Response to Comment B-8

Final Supplement to Subsequent Environmental Impact Report
Appendix N - Written Comments and Responses

Mammoth Yosemite Airport

Response to Comment C-1

Well Location Map Mammoth Yosemite Airport

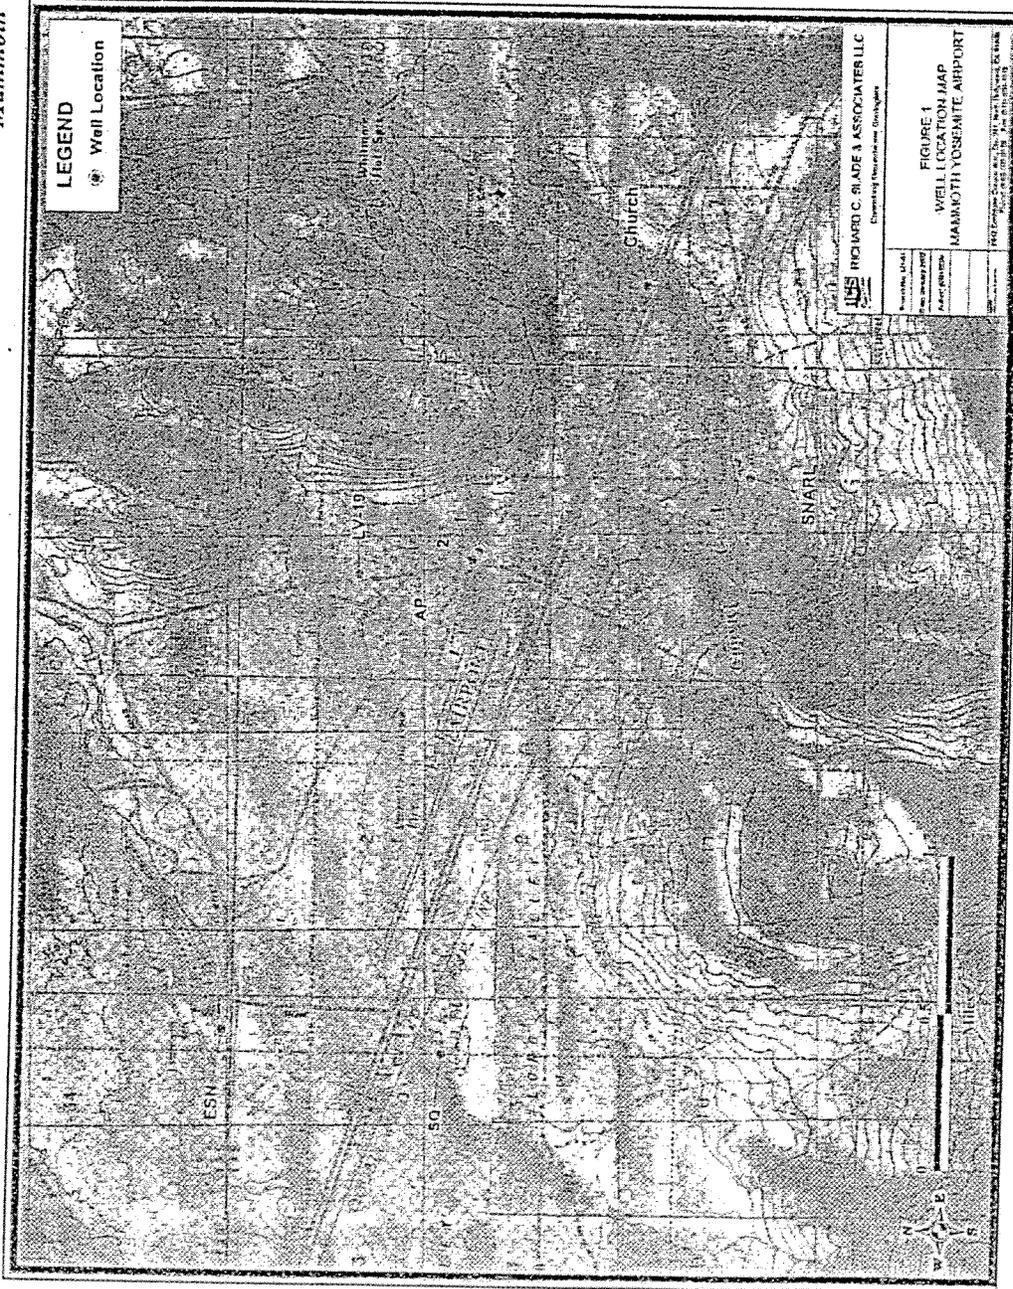
Recharge of sewage effluent from the proposed package treatment plant discharging to a leach field would develop a relatively constant head to drive a wetted front downward through vadose zone. However, recharge would only occur in a specific area and it has not been determined whether this area is hydraulically connected to the zone being pumped or whether this would even be desirable. Impacts from discharge of waste from the wastewater plant also need to be evaluated.

The estimated ground water usage of 17.94 acre-feet per year (16,000 gpd) was for the airport terminal only. When the pumping demands for the hotel, restaurant, and condominiums are added, the annual average demand is 60.4 acre-feet (from the MLWSA). This figure does not include the industrial park use or other surrounding uses. The SSEIR concludes that the area aquifer can supply 73.92 acre-feet/foot, annually. However, this supply estimate is based data from the single well test and does not include any long-term water level data which would include both wet and dry years. It is difficult to assume that the aquifer's characteristics can be accurately determined with such limited data and Board staff do not believe the estimated yield from the aquifer is supported by the data provided. In order to provide an accurate, scientifically valid evaluation of water usage and supply, the existing and projected operational conditions and hydrogeology must be thoroughly characterized. The SSEIR and other documents have not provided sufficient data to provide this characterization.

Well No. 98-1 is located west of the other two wells and Well No. 99-1 is the most easterly well. The grade of the surface of the blue clay gradually slopes from west to east. Pumping tests were conducted on both Wells 99-1 and 99-2. The water quality tests showed satisfactory primary drinking water. There were fairly high levels of iron, aluminum and zinc, which appeared to be attributable to sediments found in the samples, and it was anticipated that with usage these sediments would decrease. Water from these wells has been used since 1999 in the Airport system and the water has proven to be good quality for domestic use.

In January 2002, at the request of Lahontan Regional Water Quality Control Board (RWQCB) a pumping test was conducted on Well No. 99-1. Well No. 99-2, the Airport well, LV-19, SNARL Well, Church Well, ESN Well, and SQ Well were used as observation wells and are shown on Exhibit N-9. The purpose of these pump tests was to determine the transmissivity² of the soil, the capacity of the well, the draw down of the water table due to pumping, and the rate of recovery after pumping stopped. These tests were conducted by Triad/Holmes Associates and Richard C. Slade and Associates and support the results of previous studies, which indicated that there would be no significant impacts on hydrology, water quality and water supply in the region due to the needs of the proposed Airport improvements. (See Attachment B to Response to Comments.)

These studies demonstrate that there are three separate aquifers in the Airport influence area. The upper aquifer extends from the ground surface to a depth of approximately 60 feet. The middle aquifer extends from a depth of approximately 100 feet to 136 feet. The lower aquifer extends from a depth of 270 feet to 409 feet. The upper two aquifers, in a cobble, gravel and sand soil, produce cold, quality water. The lower aquifer, in a broken rock formation, produces warm water that smells of sulfur and is apparently of geothermal origin. The upper two aquifers are separated by a cobble clay layer. The lower two aquifers are separated by a gray blue clay layer. Airport Wells No. 99-1 and 99-2 draw from the middle aquifer and the operating Airport well, and wells on other properties surrounding the Airport appear to draw from the upper aquifer.
